TULSA METROPOLITAN UTILITY AUTHORITY

**ADDENDUM 1
TO
TULSA METROPOLITAN UTILITY AUTHORITY
PROJECT NO. WPC 26-4
FY'26 WATER POLLUTION CONTROL
SOUTHSLOPE CAPITAL EQUIPMENT REPLACEMENTS**

RE: TMUA PROJECT NO. WPC 26-4, FY'26 SOUTHSLOPE CAPITAL EQUIPMENT REPLACEMENTS
SUBJECT: ADDENDUM 1 - 4/1/2026

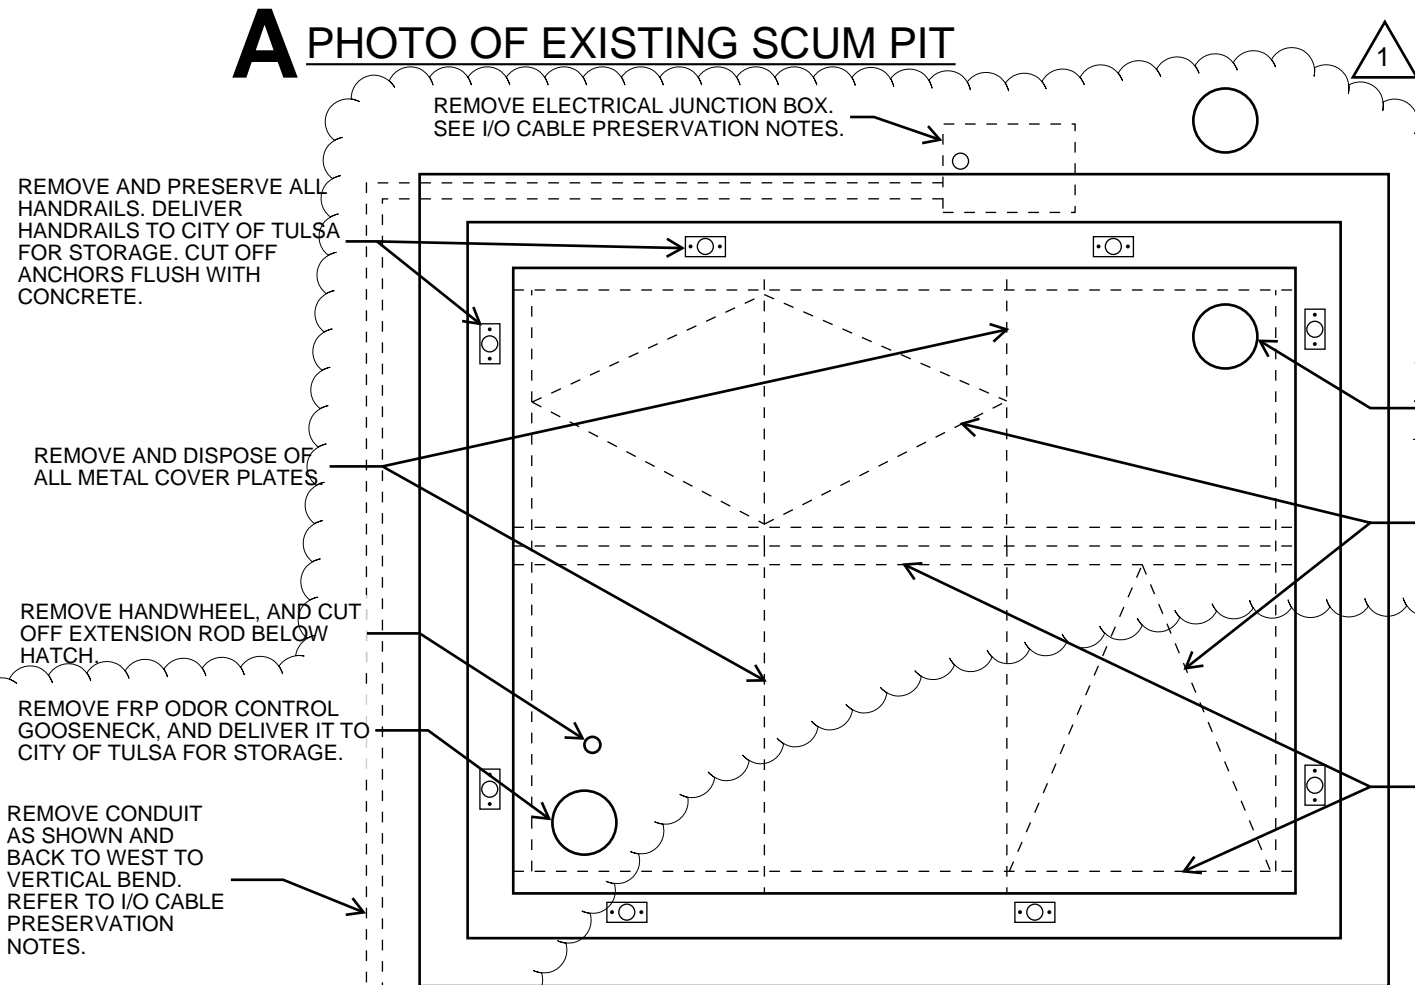
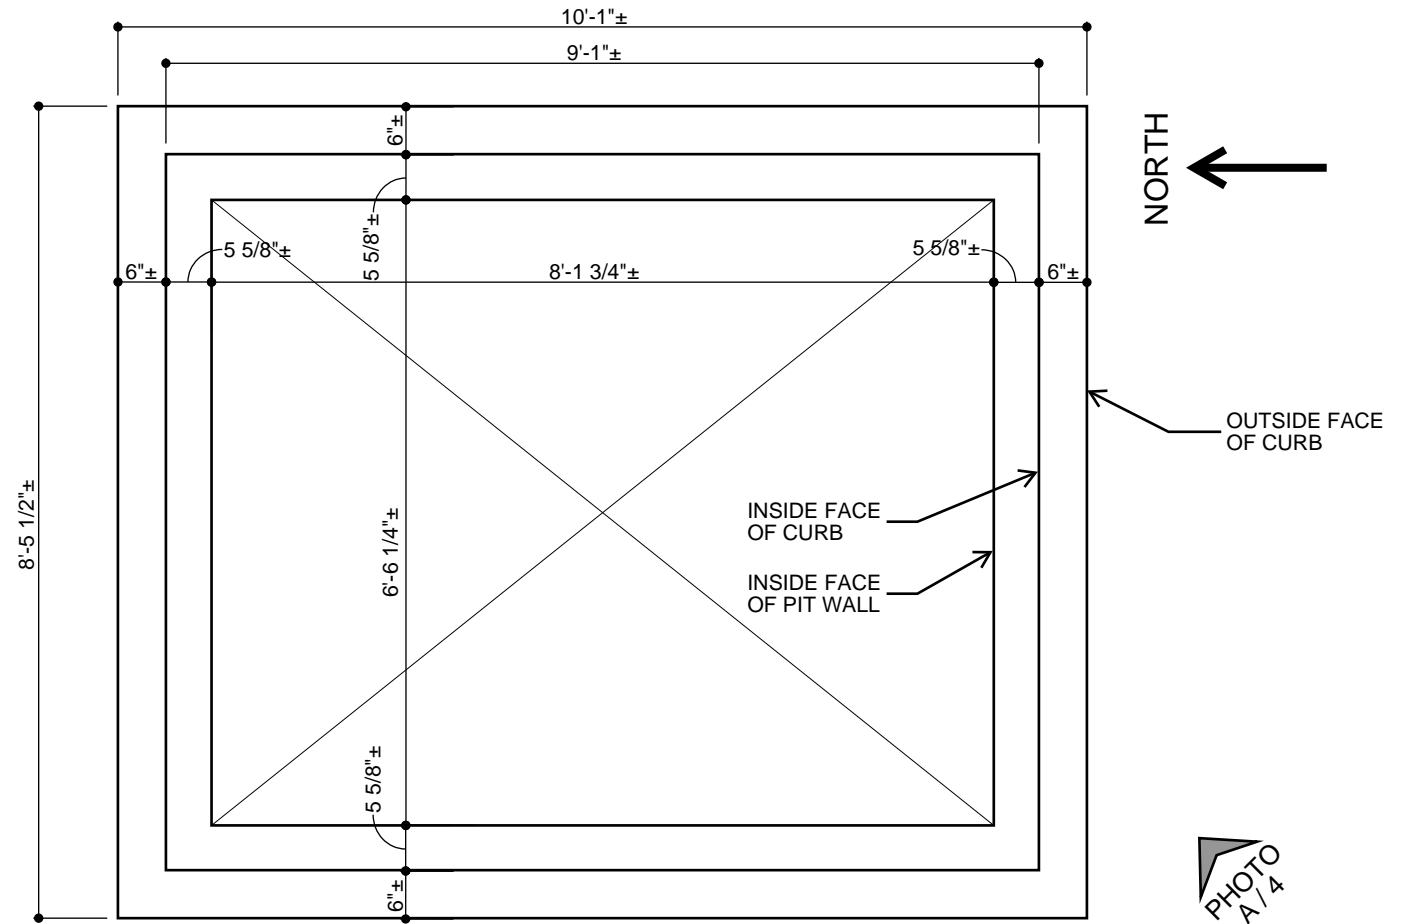
4. Pre-Bid Conference Bidder Question #4
 - a. Question: "What is to be done with the existing electrical conduit and box located at the scum pit?"
 - b. Response: Remove and replace junction box and a portion of conduit run as shown in Addendum 1, revised Sheet 4 and revised Sheet 5.

1. THE EXISTING CONDUIT AND ELECTRICAL JUNCTION BOX CONTAIN AN I/O CABLE THAT IS IN SERVICE AND SHALL BE PRESERVED.
2. COORDINATE THE SCHEDULING OF THIS WORK WITH PLANT STAFF.
3. DISCONNECT CABLE FROM ITS TERMINAL END IN CABINET RIO10 IN WEST PUMP HOUSE.
4. WITHDRAW CABLE FROM CONDUIT AND JUNCTION BOX TO FACILITATE DEMOLITION OF CONDUIT AND BOX.
5. MAXIMUM TIME CABLE MAY REMAIN DISCONNECTED IS TWELVE (12) HOURS IN ONE DAY FROM 7:00AM TO 7:00PM.
6. SEE B/5 FOR CONDUIT AND JUNCTION BOX REPLACEMENT.

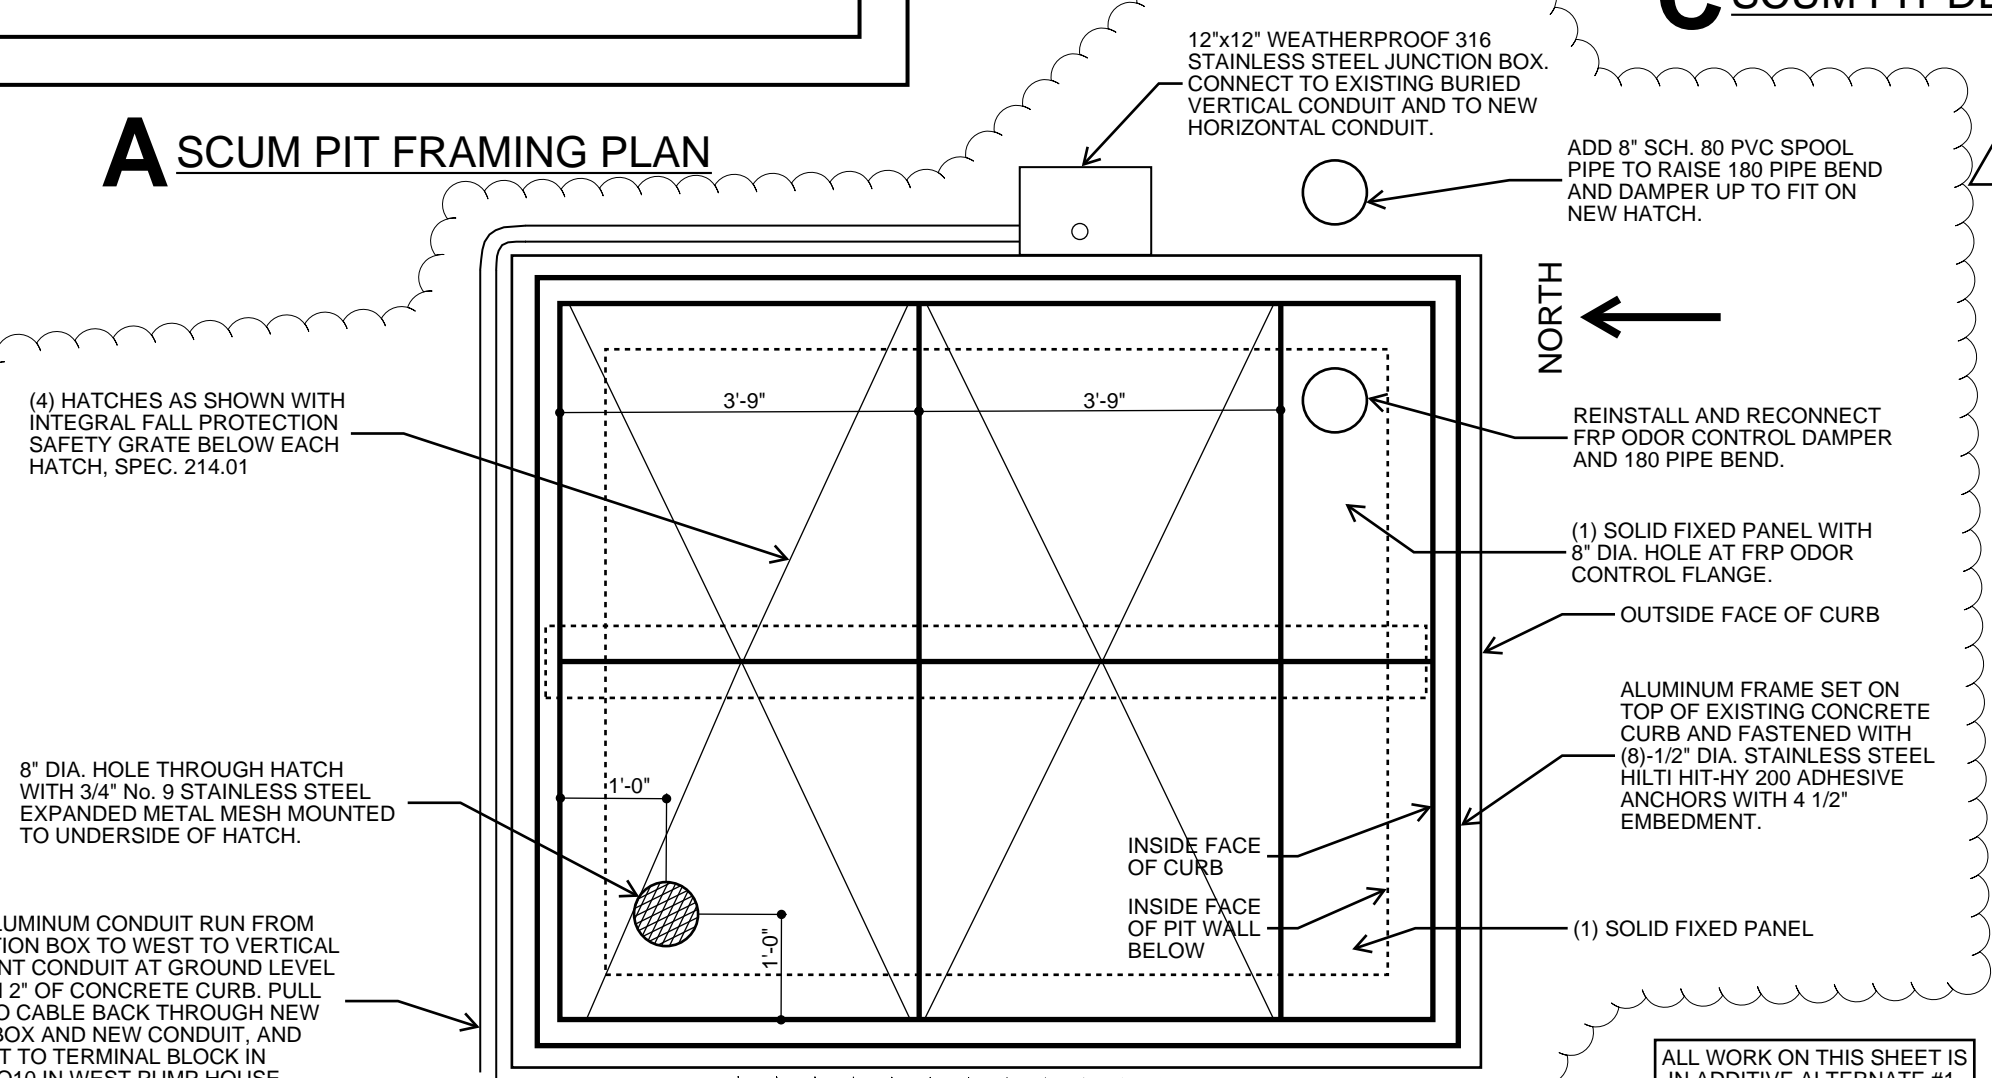
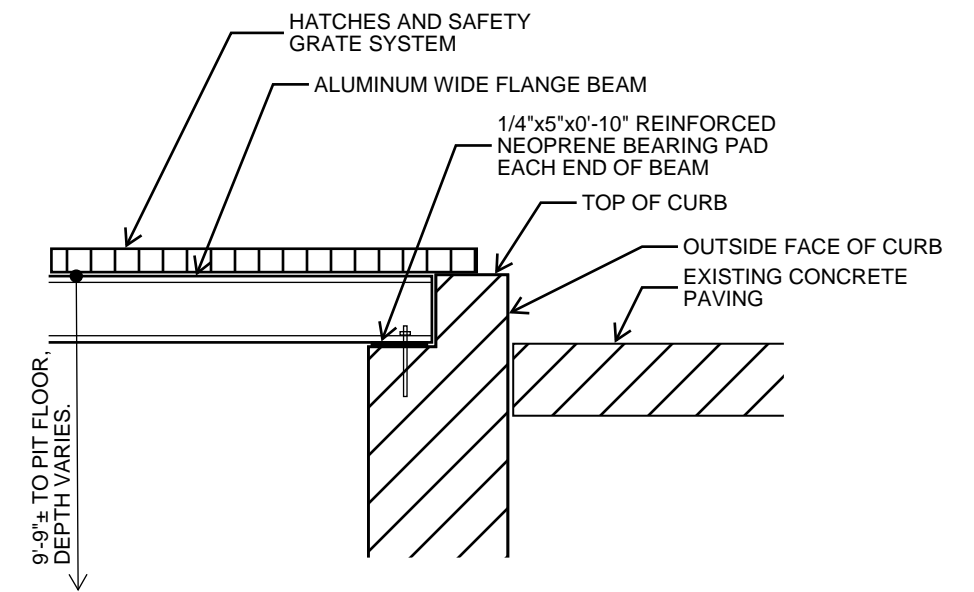
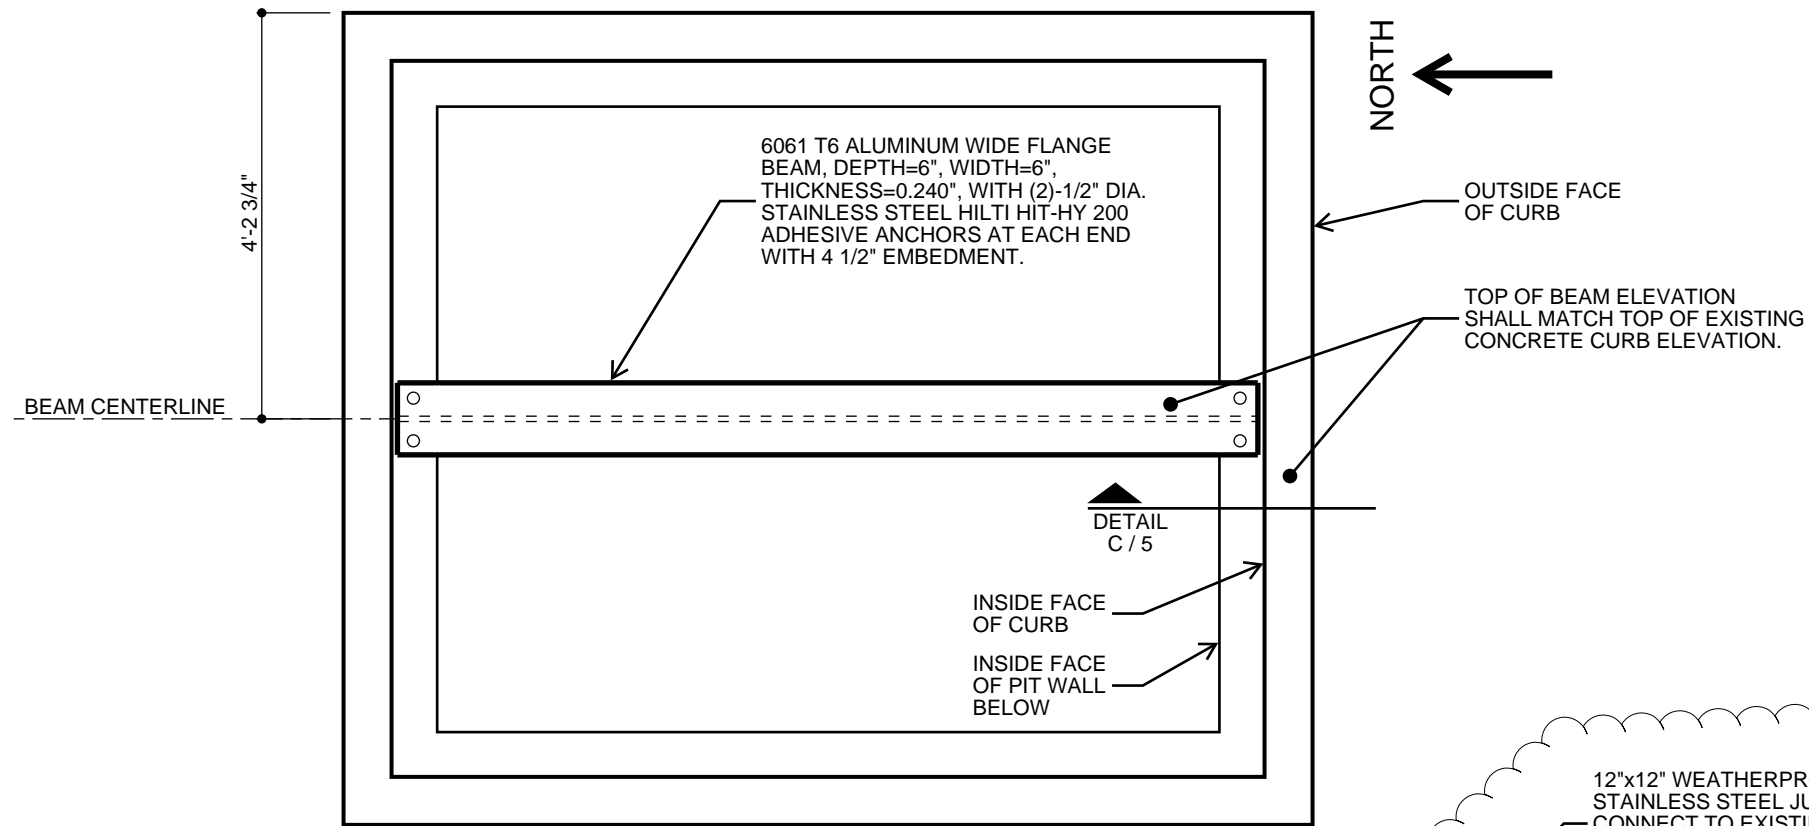
5. Pre-Bid Conference Bidder Question #5
 - a. Question: "Will the existing damper on the Odor Control Piping at the scum pit need to be reinstalled? If so, this will require an additional pipe spool in order to get the attachment flange at the right elevation."

- b. Response: Yes, the existing damper shall be reinstalled. Add a PVC spool pipe as shown in Addendum 1, revised Sheet 5.
6. Pre-Bid Conference Bidder Question #6

B EXISTING ROOF PLAN

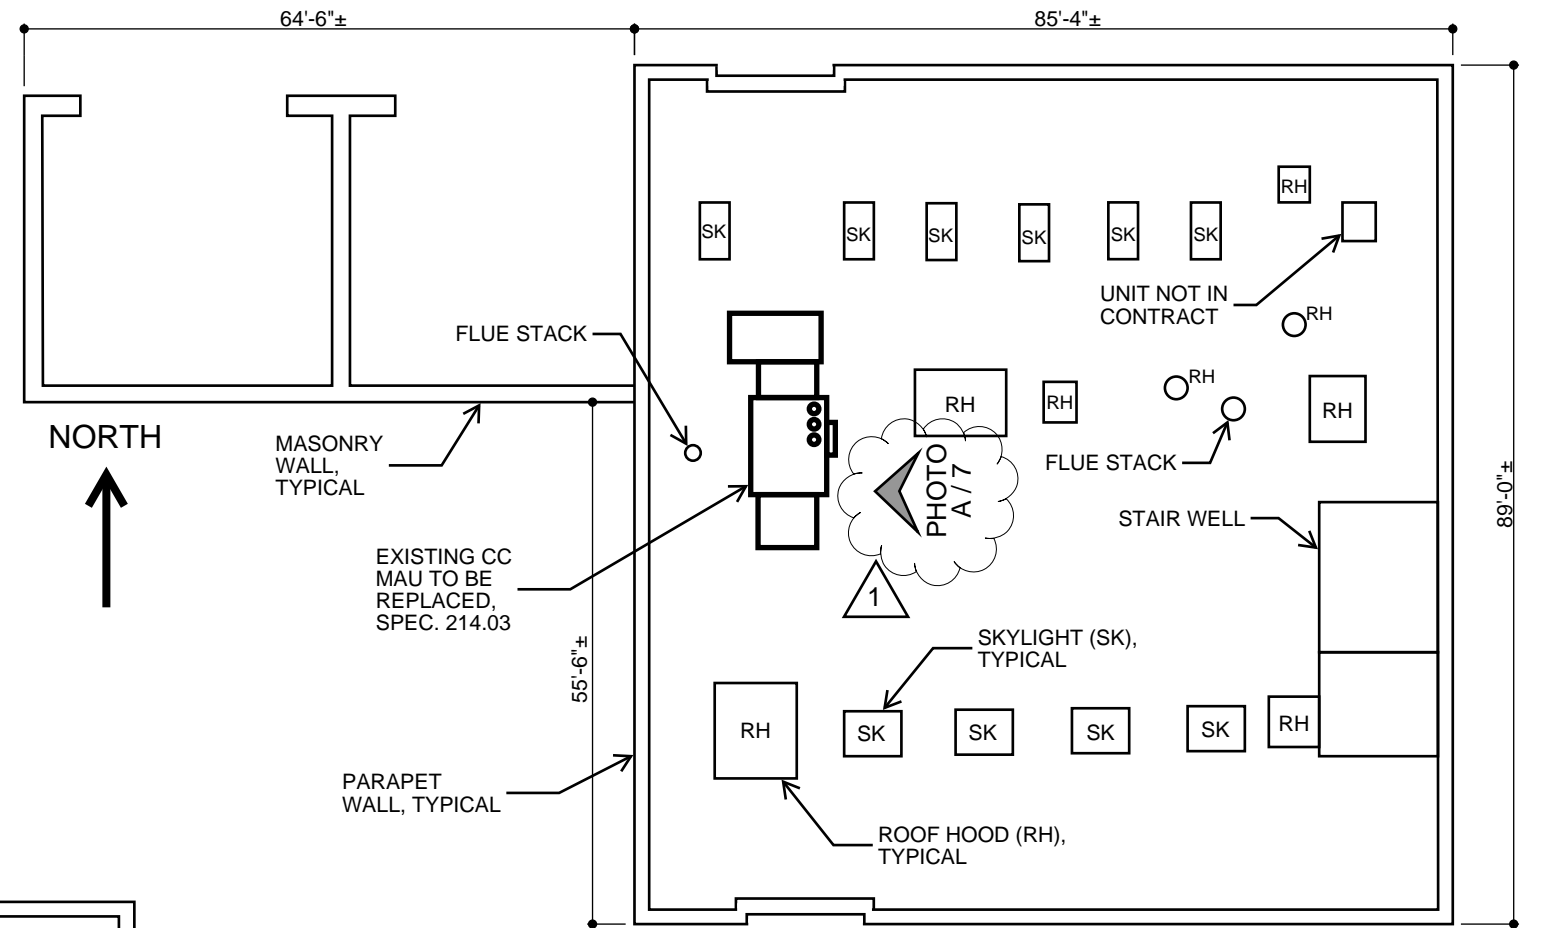
- b. Response: Yes, install pressure gauges and switches on isolation rings to match the existing configuration. And, yes, Owner will provide available information regarding existing equipment during construction.
- 7. Refer to SHEET 4 - ADD. ALT. #1 SCUM PIT HATCH REPLACEMENT
 - a. Replace entire drawing with the attached drawing.
 - b. Revise C - DEMOLITION PLAN as shown on the revised drawing.
 - c. Add D - I/O CABLE PRESERVATION NOTES as shown on the revised drawing.
- 8. Refer to SHEET 5 - ADD. ALT. #1 SCUM PIT HATCH REPLACEMENT
 - a. Replace entire drawing with the attached drawing.
 - b. Revise B - SCUM PIT HATCH PLAN as shown on the revised drawing.
- 9. Refer to SHEET 7 - CC MAKE-UP AIR UNIT REPLACEMENT
 - a. Replace entire drawing with the attached drawing.
 - b. Revise B - EXISTING ROOF PLAN as shown on the revised drawing.
